PUBLIC HEARING MEMORANDUM

38 Richardson Street

ZONING REVIEW MEMORANDUM

Re: Special Permit – 38 Richardson Street

Proposed site plan

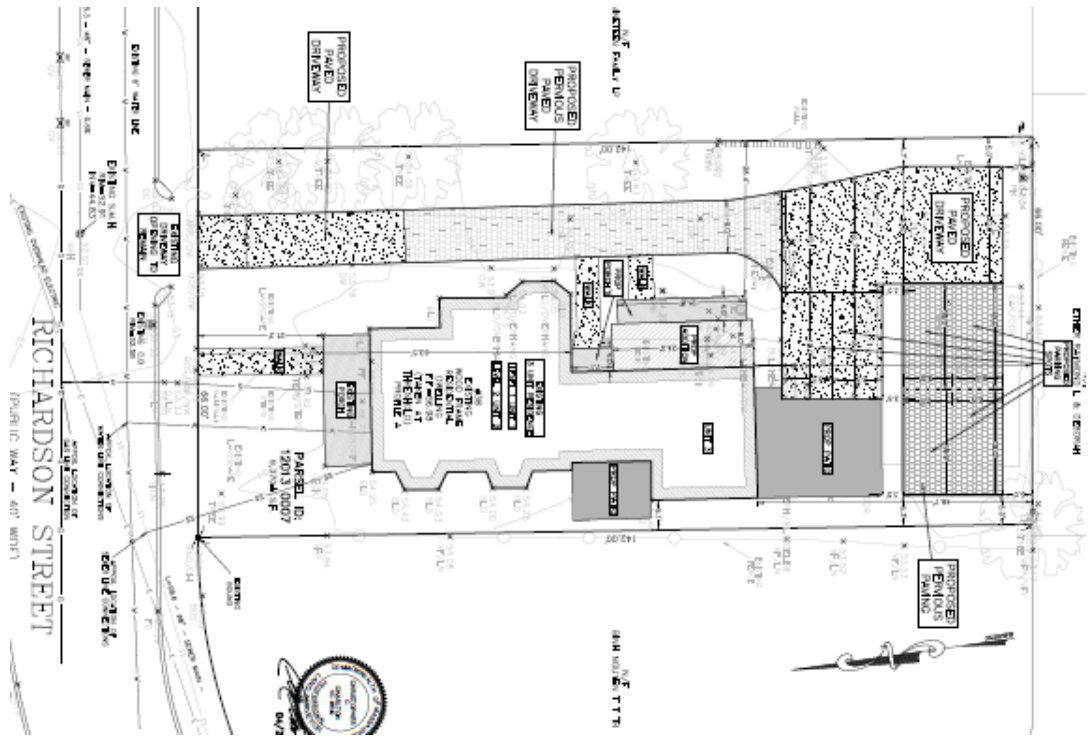
The Planning Department notes that the Petitioner is seeking relief from requirements related to parking stalls' width and depth. Indeed, the submitted proposed surveyed site plan

indicates all six stalls would measure 8 ½ by 18 feet. However, submitted architectural drawings of the site seem to indicate that the stalls would have 9-foot widths. The Petitioner should clarify this in advance of or at the public hearing. The Petitioner should also clarify whether the sought relief to allow outdoor parking within five feet of a dwelling is required as the need is not necessarily indicated on the submitted plans.

Several of the proposed parking waivers relate to auto circulation on the site, namely those seeking approval of a maneuvering aisle measuring as little as 17.3 feet in width, a 9-foot wide two-way driveway and four tandem stalls. These raise some concerns for the Planning Department given the amount of car movement that might be required in the rear of the lot, especially given the proposed tandem stalls. That said, concerns might be somewhat reduced by the fact that the parking area and driveways would be utilized by residents who would be expected to be familiar with the lot.

The petitioner proposes to locate two parking stalls within 5 feet of the western side lot line where 7.5 feet is required, requiring a special permit. Relatedly, relief is requested from the requirement to provide perimeter screening for the parking area. While vegetation proposed for the rear property line, including four trees (note: similar trees are proposed to be installed elsewhere on the property; the petitioner should confirm the number and location of all trees proposed to be installed), would provide some screening of the parking area from the abutting residential property directly to the rear, no screening vegetation is proposed for the rear right (west) side of the property where two stalls would extend into the right side setback. Perhaps this lack of screening is a response to the existence of a six-foot high fence in the area. However, this fence is located on an abutting property, not the subject site. As such, the Planning Department suggests that the petitioner fully explore relocating/realigning those stalls outside of the setback and/or providing appropriate on-site vegetative screening in that portion of the lot's perimeter.

Regarding the requested waiver from the requirement that the proposed parking areas be permanently striped, it is unclear to the Planning Department as to why this requirement cannot be met or what a potential benefit of such a waiver would be. Regarding the requested exception to the requirement that surface parking facilities used at night are required to provide a minimum lighting intensity of one-foot candle over the entire facility, the Planning Department is generally not concerned with this request given the residential nature of the site and abutting properties.
